# UNITED STATES PATENT AND TRADEMARK OFFICE

APPLICATION NO.	FILING DATE	FIRST NAMED INVENTOR	ATTORNEY DOCKET NO.	CONFIRMATION NO.
10/576,715	04/21/2006	Simon Walker	P0001US1	6311
53896 7590 08/26/2009 PEAK INNOVATIONS INC. ATTN: IP LEGAL DEPARTMENT 203 - 11782 HAMMERSMITH WAY RICHMOND, BC V7A-5E2 CANADA			EXAMINER GARCIA, ERNESTO	
			ART UNIT 3679	PAPER NUMBER
			MAIL DATE 08/26/2009	DELIVERY MODE PAPER

### Office Action Summary

## **DETAILED ACTION**

**FIG. 8B**

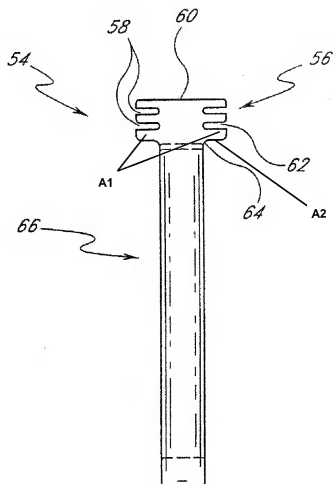
Regarding claim 1, Larsen discloses, in Figures 8A and 8B, an ornamental picket spacer comprising an elongated spacer member **56** and an ornamental member **66**. The elongated spacer member **56** has generally parallel sides **A1** (see marked-up attachment) and a wall **A2** extending therebetween. The ornamental member is connected to the wall **A2**.

Regarding claim 13, Larsen discloses, in Figures 8A and 8B, a kit comprising an elongated spacer member **56** and an ornamental member **66**. The elongated spacer member **56** has generally parallel sides **A1** and a wall **A2** extending therebetween. Note that the ornamental member is able to be connected to the wall **A2**.

Regarding claim 15, Larsen discloses, in Figures 8A and 8B, an ornamental picket spacer comprising an elongated spacer member **56** and an ornamental member **66** connected to the elongated spacer member **56**.
